**Marion County
Board of County Commissioners**

PLANNING & ZONING SECTION STAFF REPORT

P&ZC Date: 9/25/2023	BCC Date: 10/17/2023
Case Number:	231007ZP	
CDP-AR:	30469	
Type of Case:	Rezoning from General Agriculture (A-1) to Planned Unit Development (PUD)	
Owner	Fun N Games, LLC/Jon Kurtz, MGR	
Applicant	Paolo Mastroserio	
Street Address	7875 SW 75 th Ave	
Parcel Number	35461-000-00	
Property Size	18.13 acres	
Future Land Use	Medium Residential (MR)	
Zoning Classification	General Agriculture (A-1)	
Overlay Zone/Scenic Area	Urban Growth Boundary and Secondary Springs Protection Zone	
Staff Recommendation	APPROVAL WITH CONDITIONS	
P&ZC Recommendation	APPROVAL , 5-2	
Project Planner	Kenneth Weyrauch, Deputy Director	
Developer's Agreement	None	
Related Case(s)	23-S06, Land Use Amendment, from Low Residential to Medium Residential on 18.13 acres

**Figure 2
Conceptual Plan**

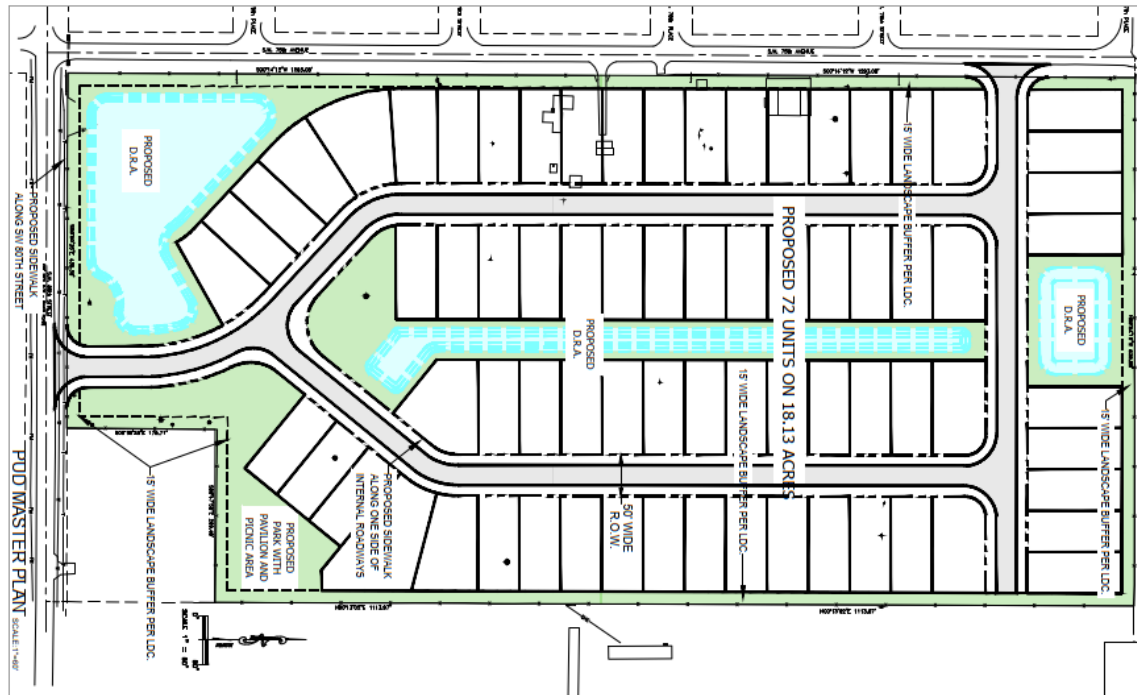
The PUD offers 3.63 acres of open space, meeting the minimum requirement of 3.63 acres of open space. Staff does have concern about the calculation of the open space as it appears the application may be trying to count the stormwater infrastructure at 100% rather than the LDC allowance of 25%. The application proposes a park of less than one acre with a pavilion for recreational amenities. Using Census data of 2.4 persons per household, which is the average for Marion County, at 72 dwelling units, the proposed PUD may generate 173 people. This translates into 914 SF of open space per person.

Analysis: Buffer details are proposed within the application (see Attachment A). Staff finds that the PUD is proposing a Type C buffer (15' wide landscape strip without a buffer wall. At least 2 shade trees and 3 accent/ornamental trees for every 100 lineal feet or fraction thereof) along the perimeter of the project, which is either meets or exceeds the standards of the Land Development Code. Staff finds that the application **meets or exceeds** requirements within this section. Notwithstanding, staff recommends the following condition be imposed:

Analysis: Proposed access points are provided within the application (see Attachment A). Staff finds the PUD proposes two access points, one on SW 80th Street and one on SW 75th Avenue. The location of access points will have to be worked out through the Development Review phase of site planning. Comments from OCE-Traffic state that the access point on SW 75th Ave should be moved south so that the access lines up with SW 78th Street at a full-access intersection. Comments also state that the Traffic Impact Analysis (TIA) did not examine either of the major intersections of SW 80th Street at SW 80th Avenue or SW 80th Street at SR 200. Notwithstanding, staff recommends the following condition be imposed:

- Prior to completion and approval of the final PUD Master Plan, the Master Plan shall be revised to show the connection to SW 75th Ave lining up with SW 78th Street.

- Prior to completion and approval of the final PUD Master Plan, the project Traffic Impact Analysis shall be revised, to the satisfaction of the County Engineer and Growth Services Director, to examine both major intersections of SW 80th Street and SW 80th Ave and SW 80th Street and SR 200. Adequate provision shall be made for the coordination of improvements with the PUD.

7. Prior to completion and approval of the final PUD Master Plan, the Master Plan shall be revised to show the connection to SW 75th Ave lining up with SW 78th Street.
